Site Plan
1632 River Road
Puyallup, WA 98371

PROJECT NAME:
LEGEND AUTO ADDITION

PROJECT ADDRESS:
1632 RIVER ROAD
PUYALLUP WA 98371

SECTIONS

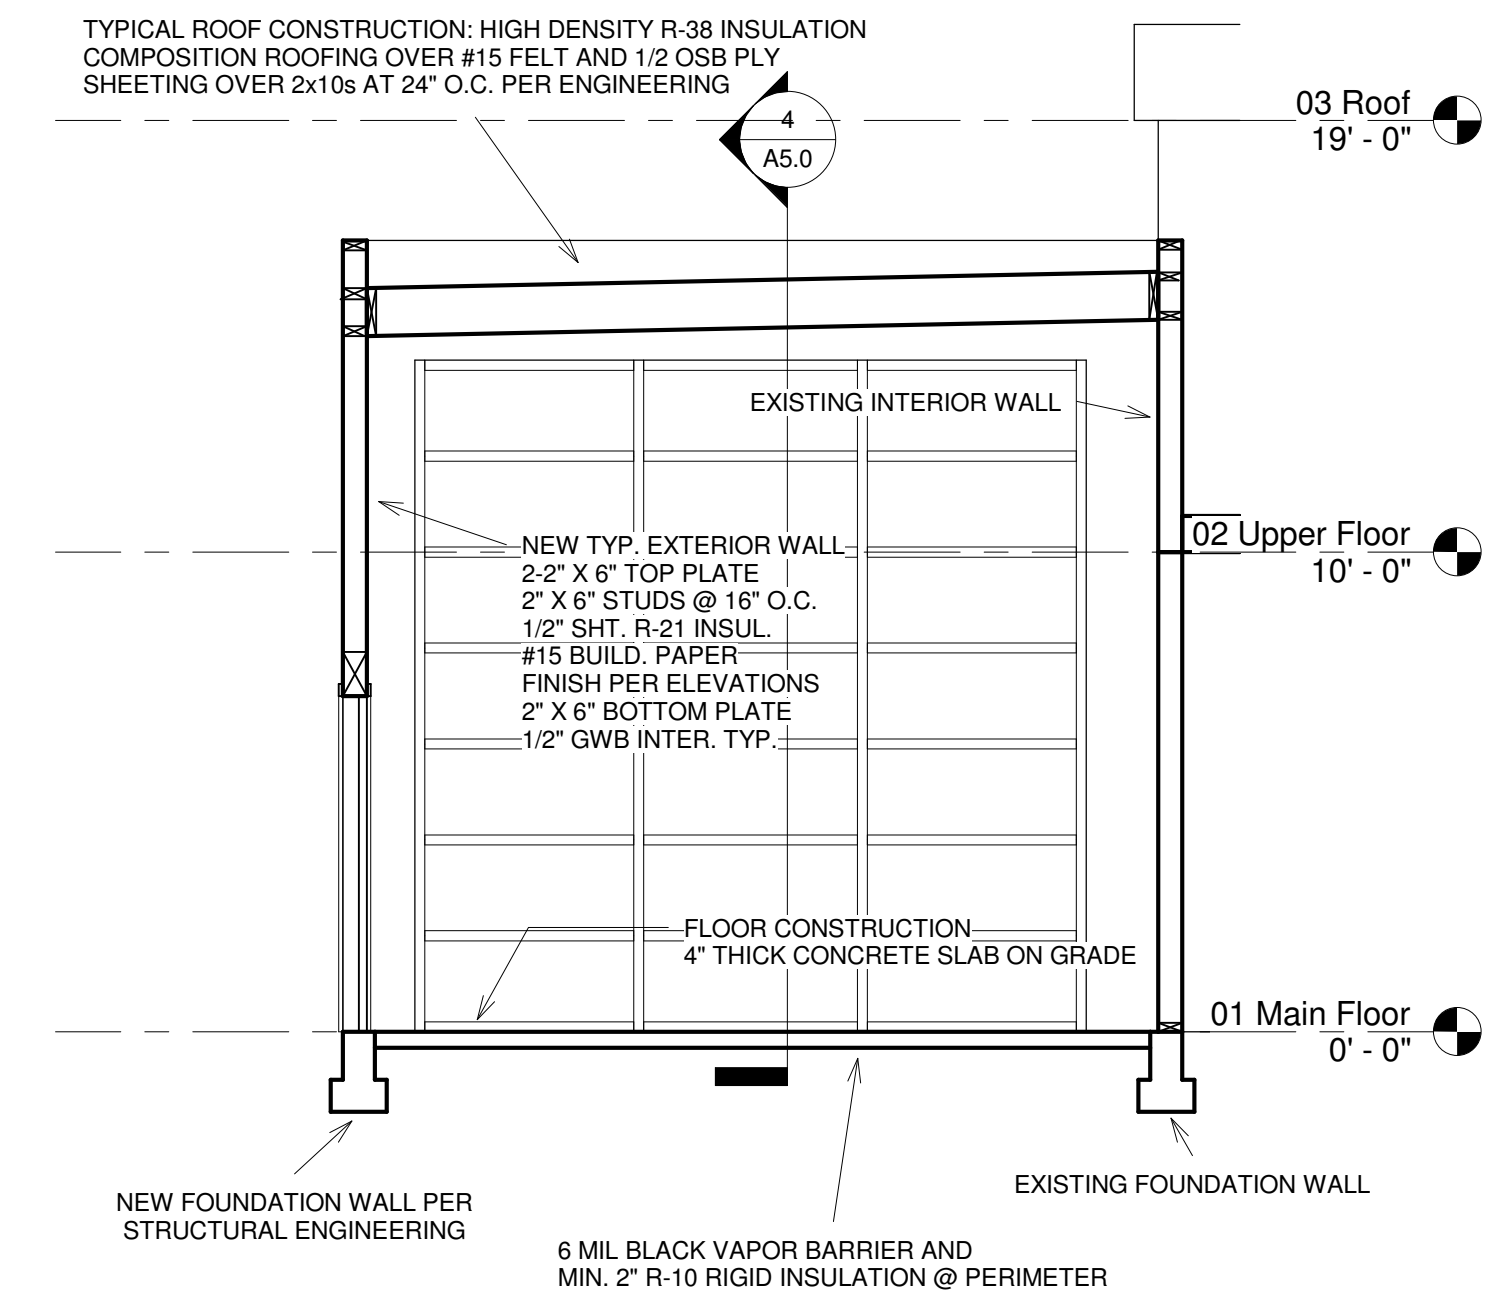
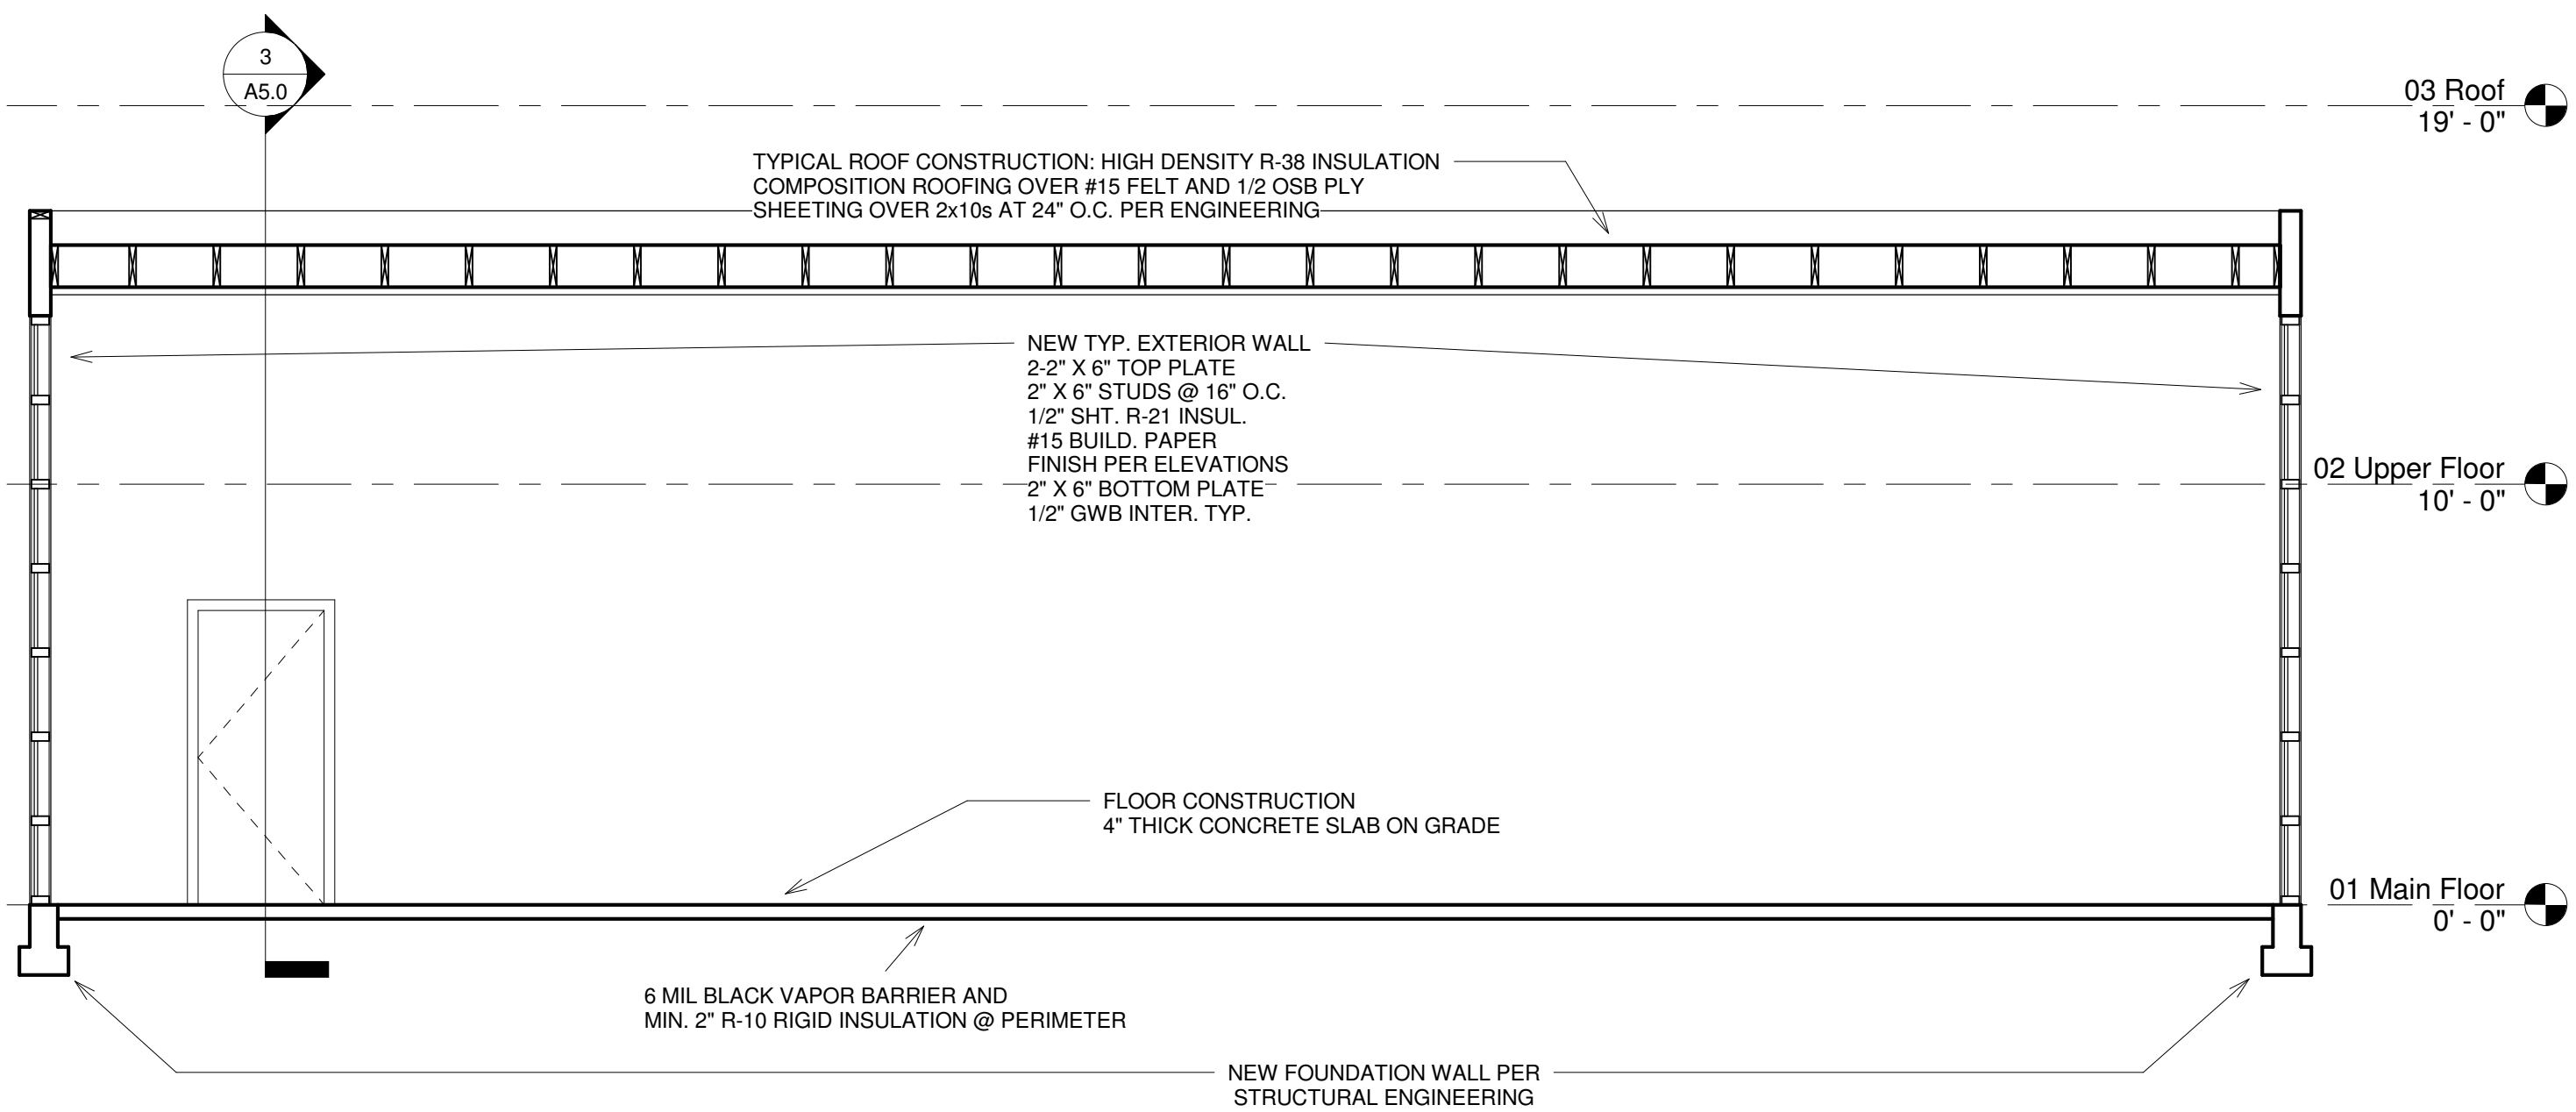
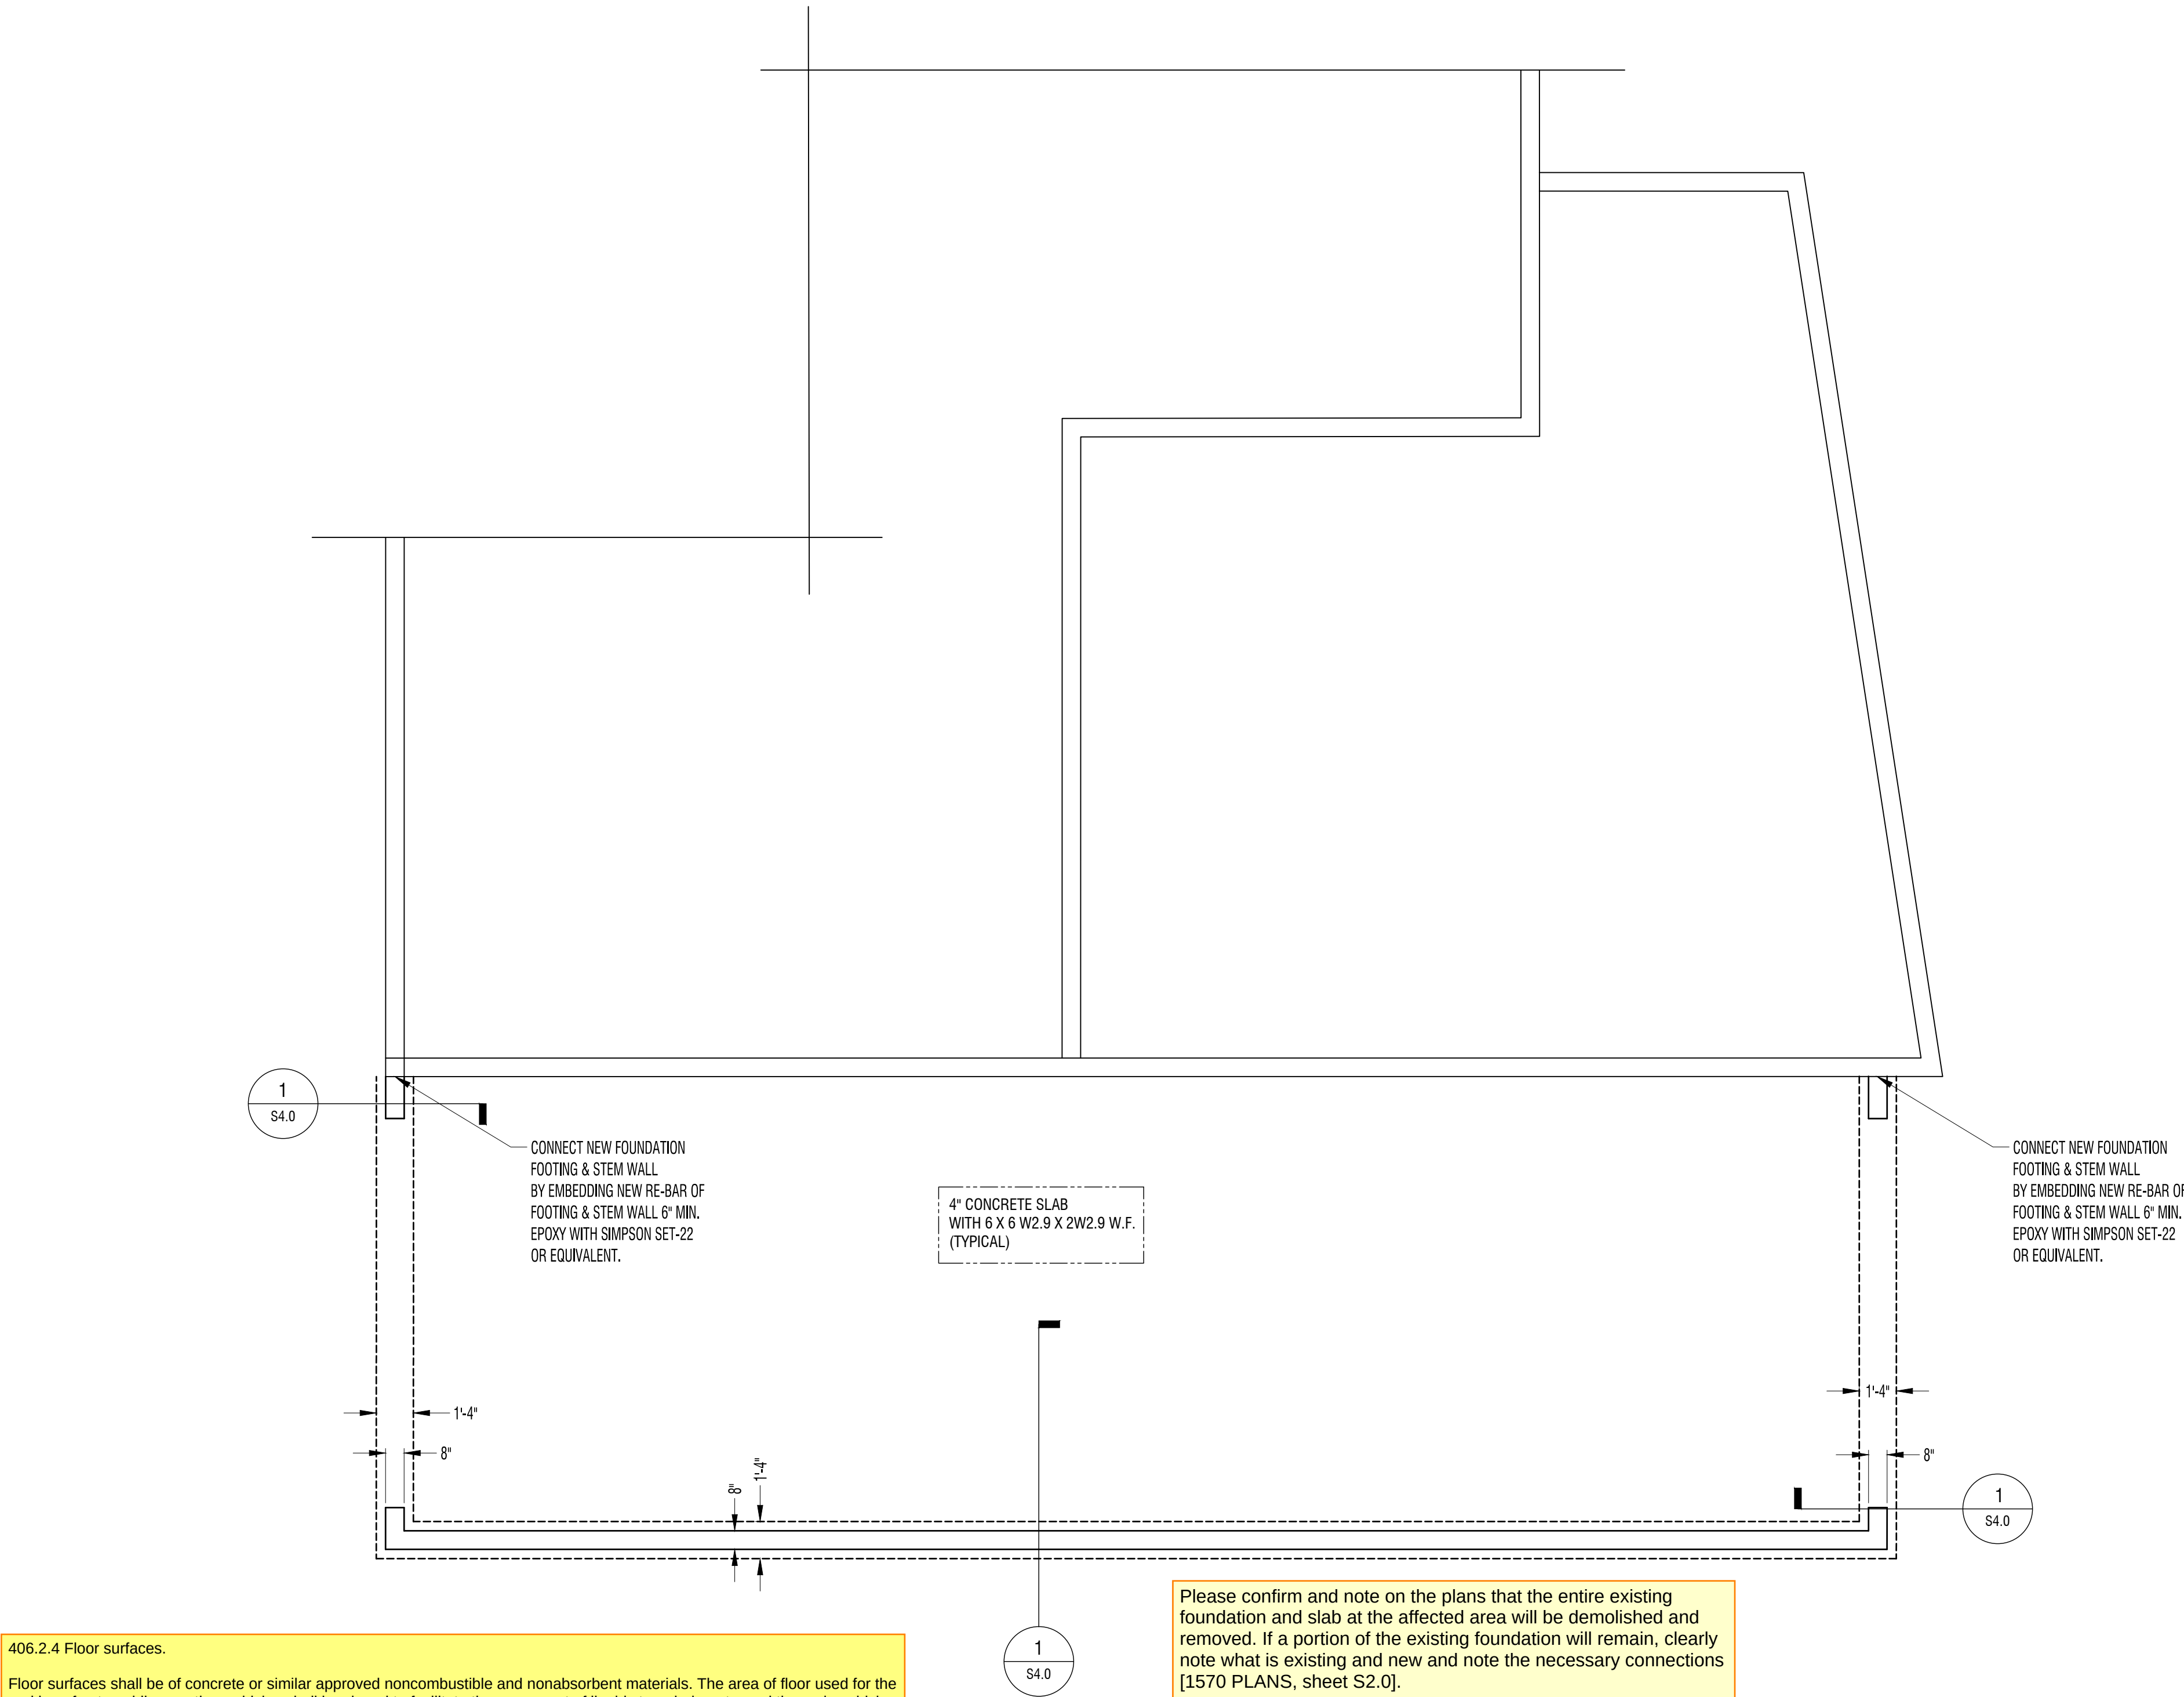
Please detail how the proposed vehicle doors will operate (roll up, tilt up, etc.). Include relevant tracks, machinery, operable space, and all manufacturer's specifications and requirements. [1570 PLANS, sheet A5.0].

DWG TITLE
MAIN BLDG FOUNDATION PLAN

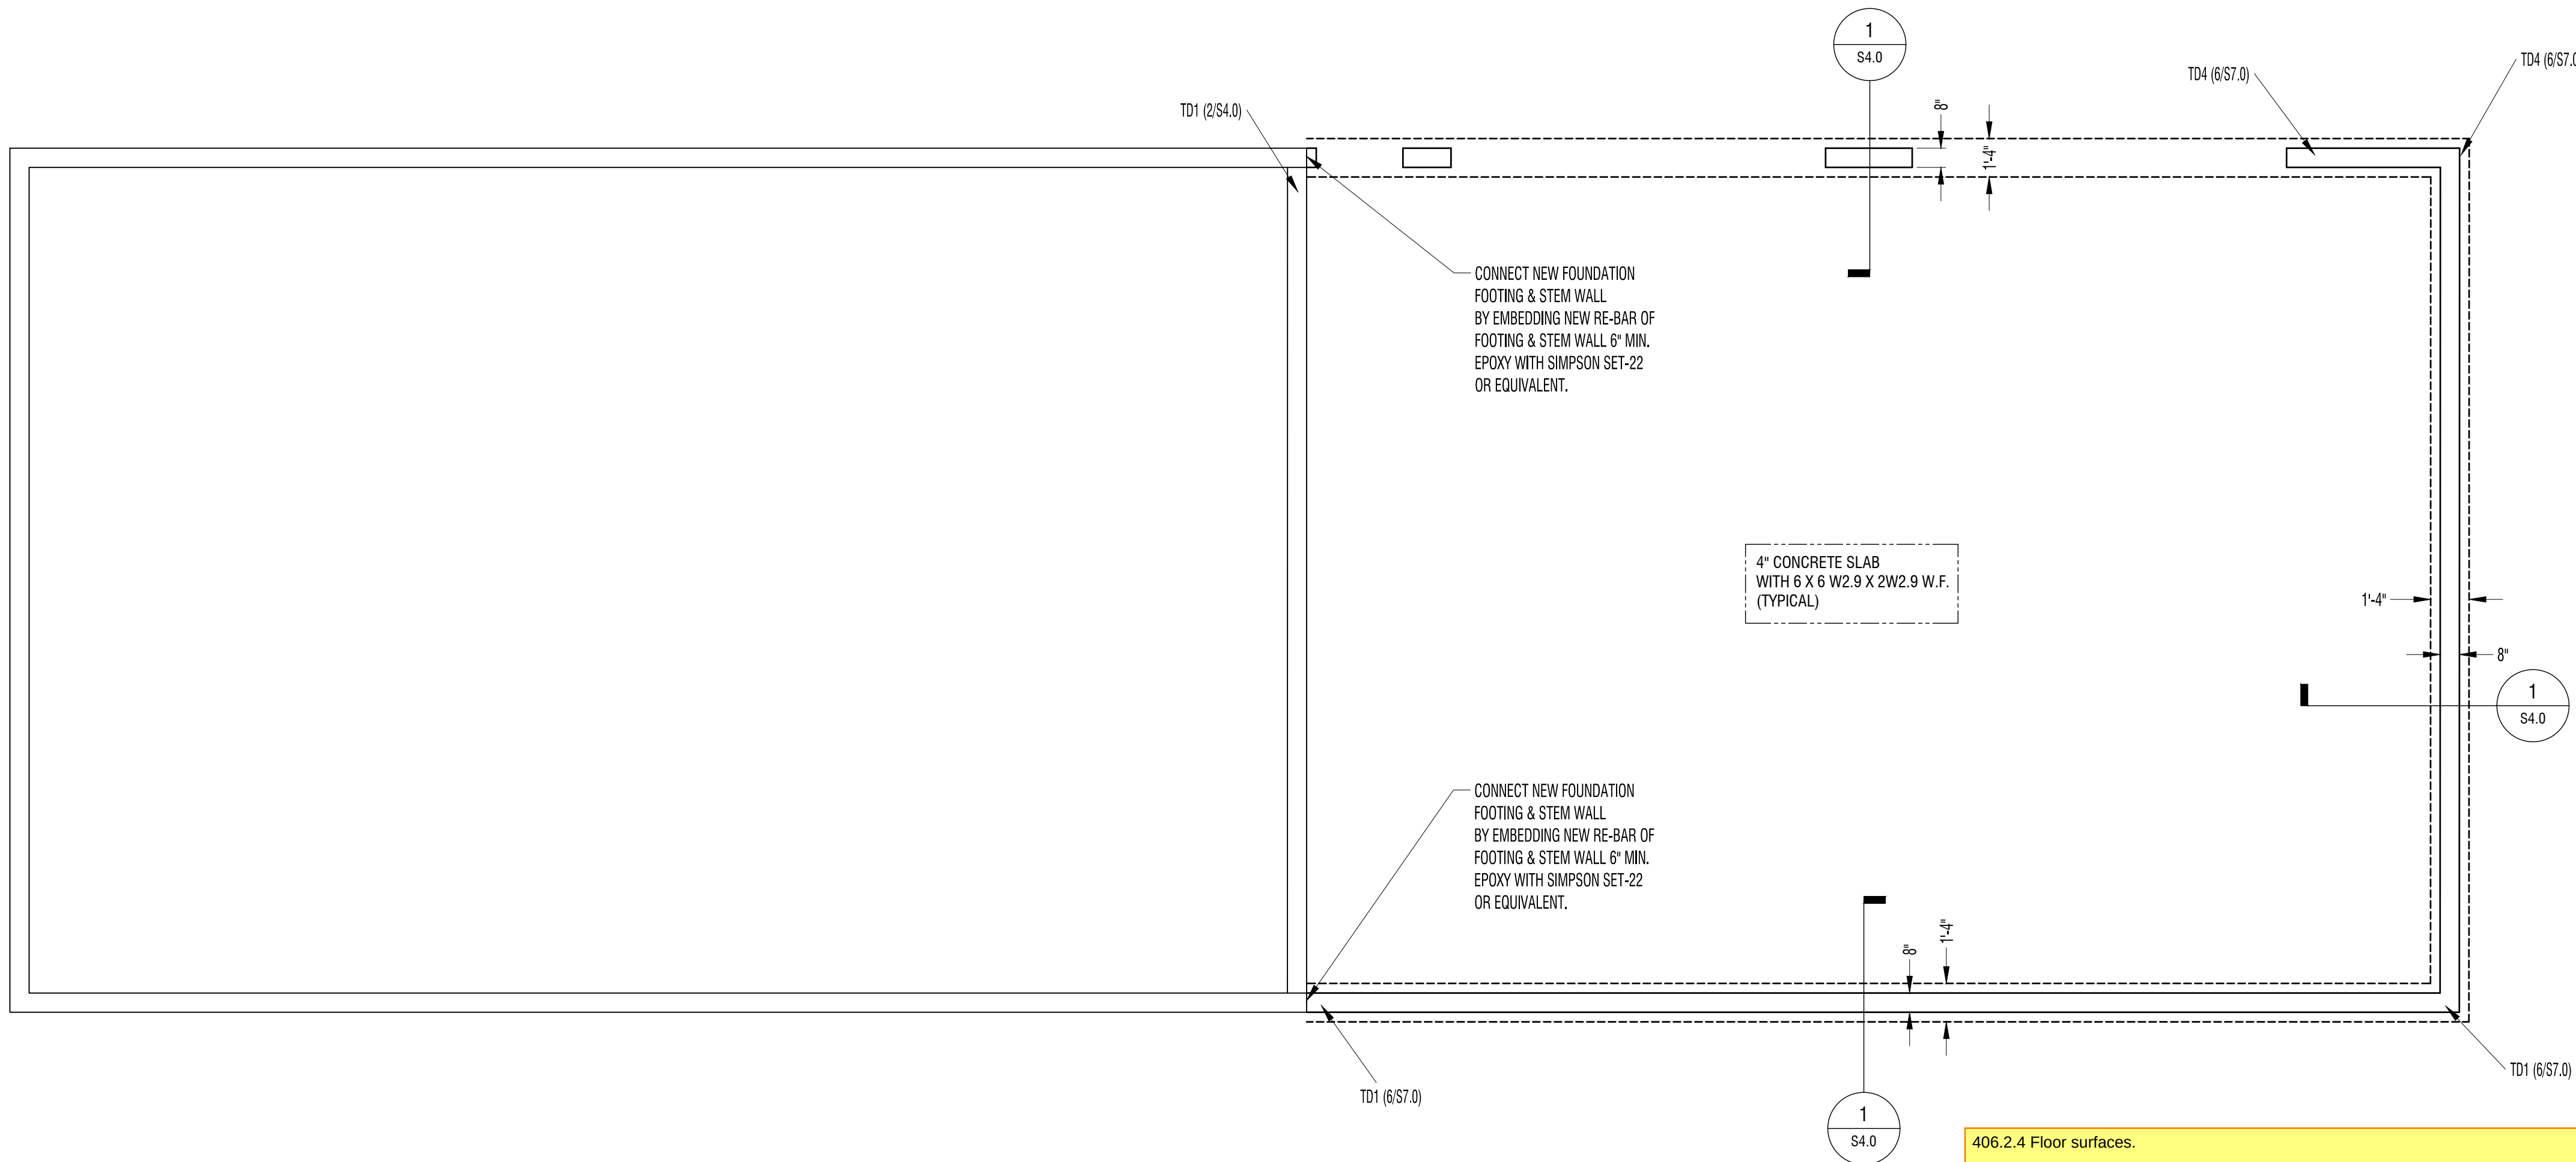
Please confirm and note on the plans that the entire existing foundation and slab at the affected area will be demolished and removed. If a portion of the existing foundation will remain, clearly note what is existing and new and note the necessary connections [1570 PLANS, sheet S2.0].
